HOMI BHABHA CENTRE FOR SCIENCE EDUCATION
Tata Institute of Fundamental Research

Minutes of Pre-bid meeting for the 'Roofing Shed Work on Main Building Canteen Terrace and NIUS TV Room Terrace at HBCSE'

A pre-bid meeting for the Roofing Shed Work on Main Building Canteen Terrace and NIUS TV Room Terrace at HBCSE, was held on 18th August, 2026 at 11:00am in Room no. G1, Main building, HBCSE.

TENTATIVE ROOFING SHED LAYOUT FOR MAIN BUILDING CANTEEN TERRACE

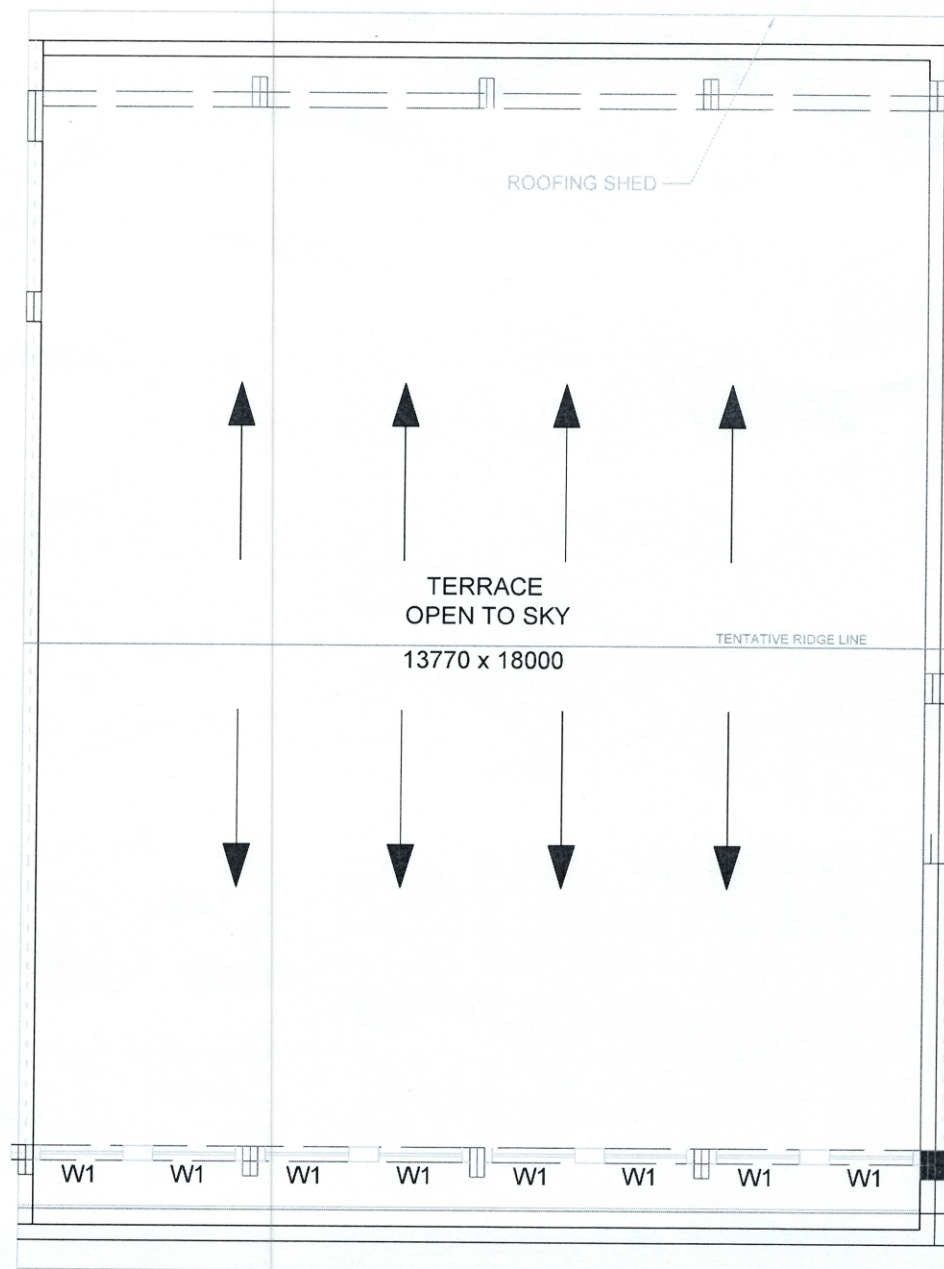
7	Will the procuring entity provide a drawing/working drawing for measurement understanding purposes for quoting a rate?	The architectural layout drawings for both terrace areas intended to be covered with PIR roof shed are attached herewith as 'Annexure – A' & 'Annexure – B'.
8	During the making of a BOQ, is there any factor of safety for steel undertaken?	The contractor-appointed structural designer can consider a sufficient optimum Factor of Safety while designing the Mild Steel structure and trusses. All loads are to be taken into consideration while designing, as
